Gatwick Airport Northern Runway Project

Second Notification of a Proposed Project Change

Application Document Ref: 10.27

PINS Reference Number: TR020005

Figure 1: Location of the on-airport WWTW facility

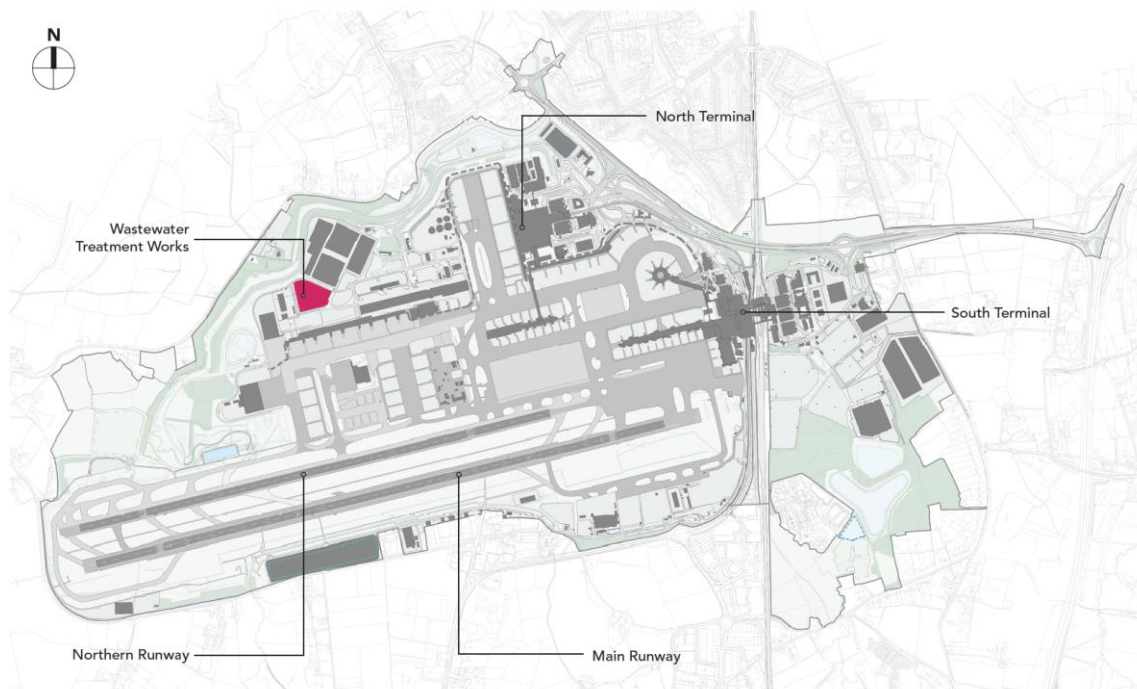
- 1.4.3 The location of the proposed on-airport WWTW is shown in pink in **Figure 1** below.

- 2.1.5 Project Change 4 comprises the:
- Provision of an on-airport Wastewater Treatment Works (WWTW) facility, located within existing Self-Park North car park shown on **ES Figure 4.2.1b** [[REP1-019](#)] and in **Figure 1** above.

Figure 2: Indicative Layout of the on-airport WWTW facility

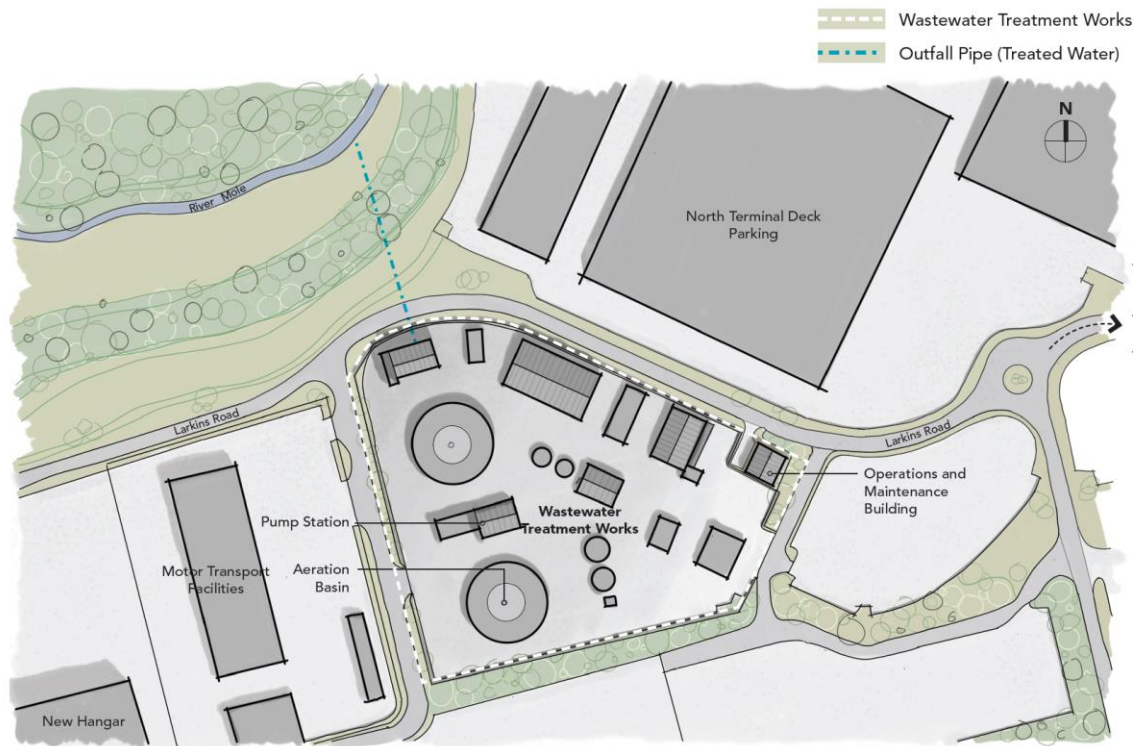
2.1.6 The on-airport WWTW facility would require a footprint of approximately 2.2 hectares. The facility would include the following physical elements, with the maximum height of the proposed structures being up to 9.4m above ground level and up to 2m below ground level:

- Headworks (the entry point for raw wastewater);
- Two circular primary clarifiers, each of approximately 12m in diameter;
- Two aeration basins, each with secondary clarifiers;
- Gravity thickeners;
- Biotower (odour control facility);
- Rotary drum thickeners, belt filter presses and tertiary disk filter facilities, each housed in a dedicated building;
- Blower building accommodating 4 blowers;
- Chemical storage building;
- Associated pipelines and pumping stations;
- Flocculation tank and a rapid mix tank;
- Sludge blend facility and sludge storage area;
- Operations and maintenance building (up to 2-storeys);
- Truck loading area; and
- Outfall from the facility to the River Mole, involving a concrete structure beside the River Mole.

2.1.7 The physical elements within the on-airport WWTW facility are shown on an indicative layout in **Figure 2** below.
